## APPLICANT RESPONSES TO ADAMS COUNTY – DEVELOPMENT REVIEW TEAM COMMENTS – 2<sup>nd</sup> REVIEW

**PROJECT NAME:** Maiker Boyers Rezoning and Preliminary Development Plan  
**LOCATION:** 7295 Washington St.  
**DATE OF COMMENTS:** 3/4/2025  
**PROJECT NUMBER:** PRC2024-00017  
**REVIEW TYPE:** Rezoning and Preliminary Development Plan Application

## EXISTING CONDITIONS AND DEMO PLAN

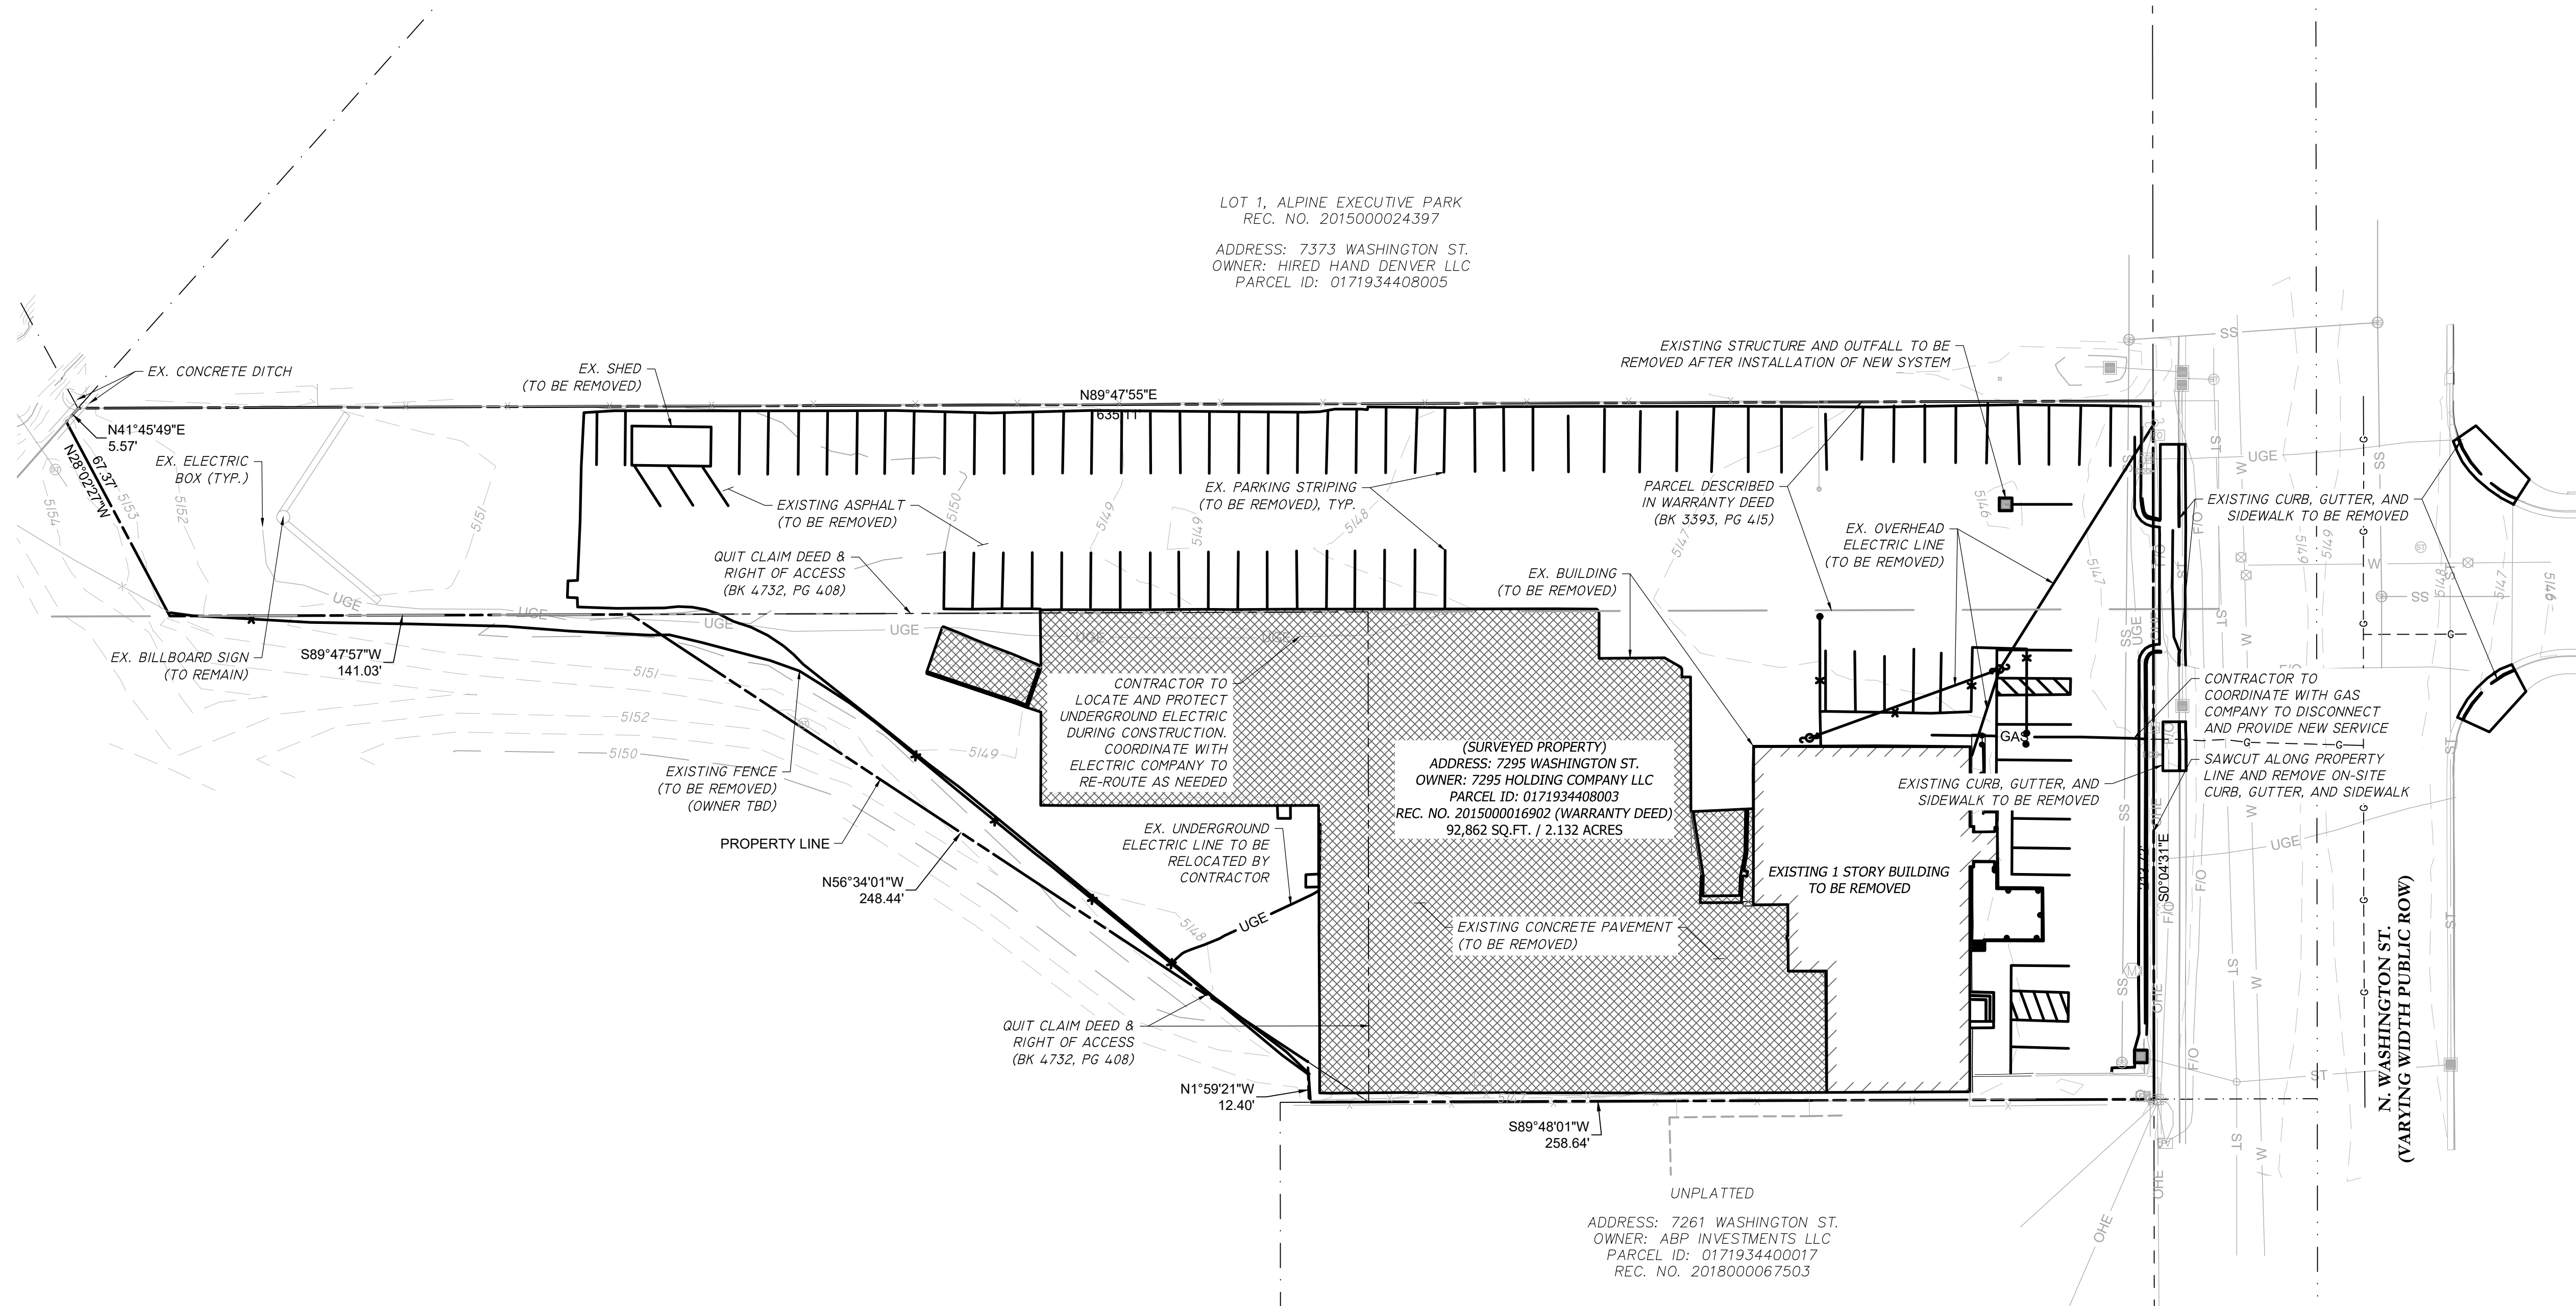
ROW2	<p>Any infrastructure/ROW improvements along Washington Street requiring dedication to the county will be by separate instrument. See comment above. Both of these dedications will be pursuant to the engineering review of the civil construction plans and exhibits reviewed and approved prior to processing.</p>
	<p><b>Response: (R&amp;R) Noted. Separate Instruments to be provided during final development plan once improvements and locations of dedications are further along in design process. This will be completed towards the end of final engineering approval or immediately after. See sheet C1.01 for preliminary linework for ROW dedications.</b></p>
<p><b>Commenting Division: Development Services, Engineering:</b>  <b>Name of Review:</b> Caio Gajdys / Civil Engineer I  <b>Email:</b> <a href="mailto:agajdys@adcogov.org">agajdys@adcogov.org</a></p>	
ENG1	<p>The developer will be required to bring the two ADA ramps on the west side of Washington St. up to current standards. It is advisable to also bring the two east side ramps up to current standards, as this is a multimodal oriented development.</p>

<b>Response: We propose to bring ADA ramps on both the east and west sides of Washington street, adjacent to the site, up to current code standards. Callouts have been added for ADA ramps on the east and west side of the street to sheet C1.01.</b>
ENG2	The County is requesting that the off-site bus shelter be relocated to the frontage of this development to better serve the property. The bus shelter may be located as much in the Right of way as possible, but if any portion of it is on the development's property, an easement will be required for that portion.
	<b>Response: The developer is amenable to relocate the current off-site bus stop, located north of our site, to the frontage of this development provided we are allowed to encroach into the existing ROW to avoid losing parking spaces, as noted above. We will provide a standard RTD shelter or similar approved shelter at this bus-stop. An area for the proposed bus stop shelter has been indicated on both the architectural and civil plans on sheets C1.01 and A1.00. We will continue to coordinate with RTD on the relocation of this bus stop to our property frontage.</b>

1. C1.00 – Demolition notes added to indicate removal of existing curb, gutter and sidewalk at existing ADA ramps, which will be brought up to current code standards.
2. C1.01 – Notes and drawings updated to incorporate additional scope of adding new mast arm, bringing existing ADA ramps up to current code standards, and adding bus stop shelter to property frontage.
3. C1.01 & C1.02 – Proposed maintenance access and drainage easement for storm water quality elements adjusted to include expanded site access per ROW comments.

C1.01

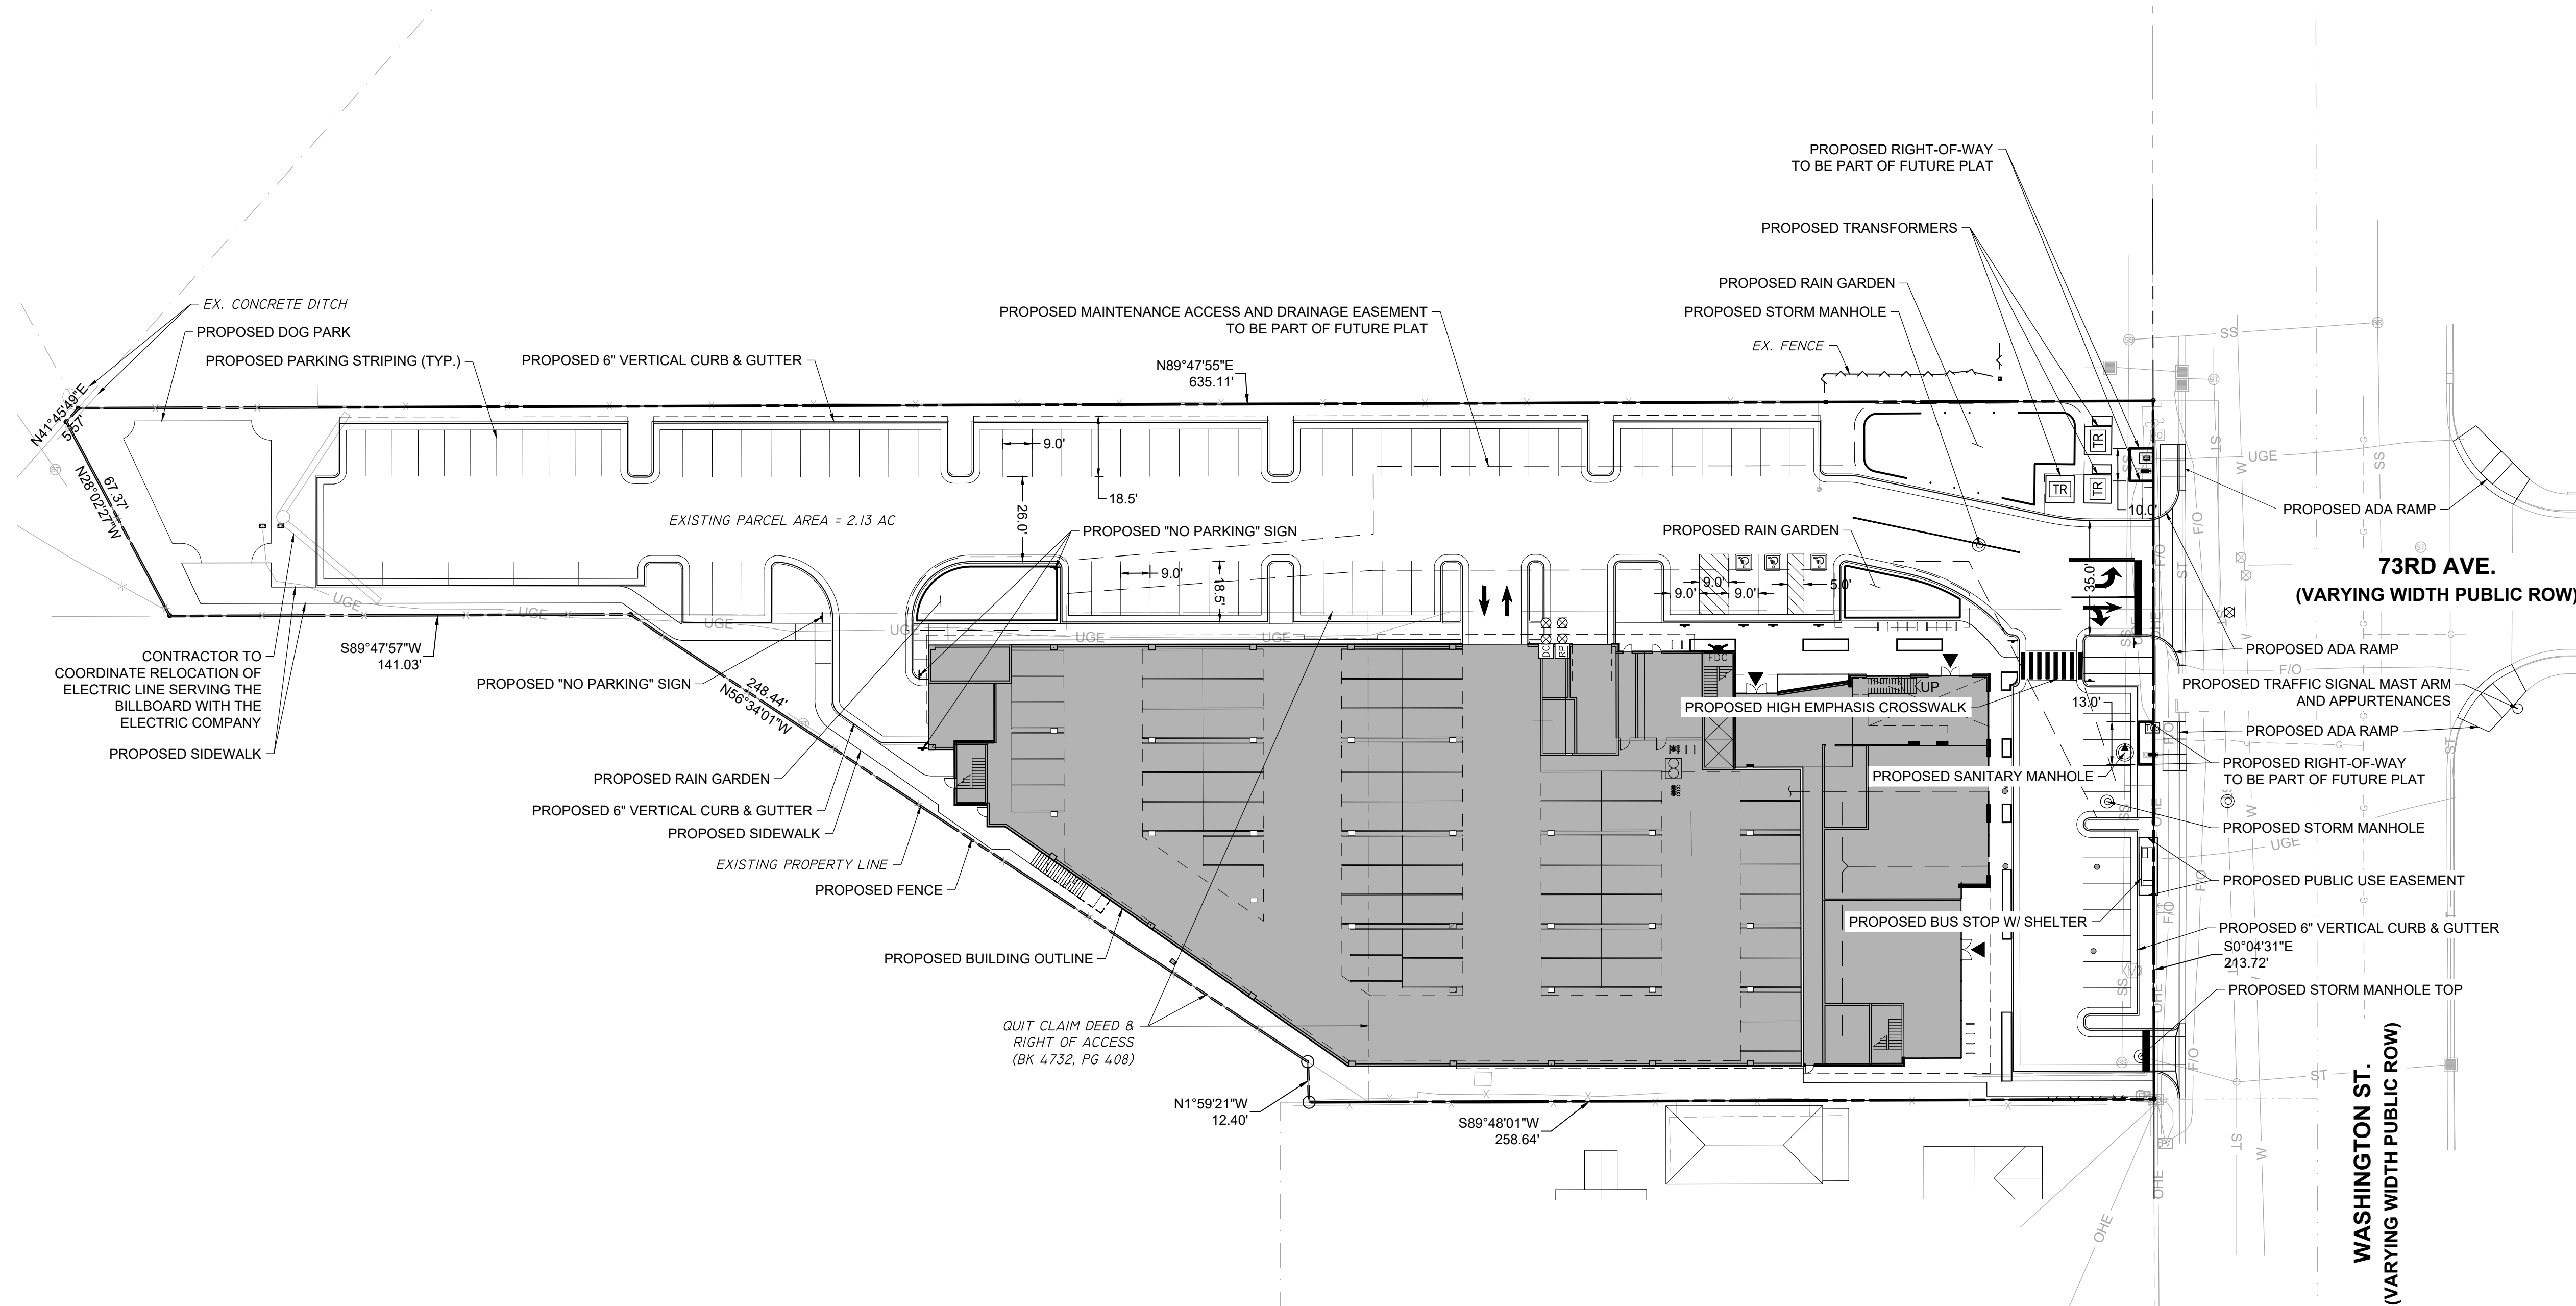
<p><b>Commenting Division: Development Services, Right-of-way:</b>  <b>Name of Review:</b> David Dittmer / Right-of-way Agent  <b>Email:</b> <a href="mailto:Ddittmer@adcogov.org">Ddittmer@adcogov.org</a></p>	
ROW1	<p>Any water quality locations, detention, and storm water facilities must be dedicated to the county by separate instrument. An Exhibit A for access to these locations by m/b legal description and illustration to match must be provided. Public Works ROW team will provide the easement document for the dedication, and ROW and Easement Application packet for required information.</p>
	<p><b>Response: Exhibits, legal descriptions, and applications for dedications will be provided during final development plan once storm water facilities are further along in design process. This will be completed towards the end of final engineering approval or immediately after. See sheet C1.01 for preliminary linework for this easement.</b></p>
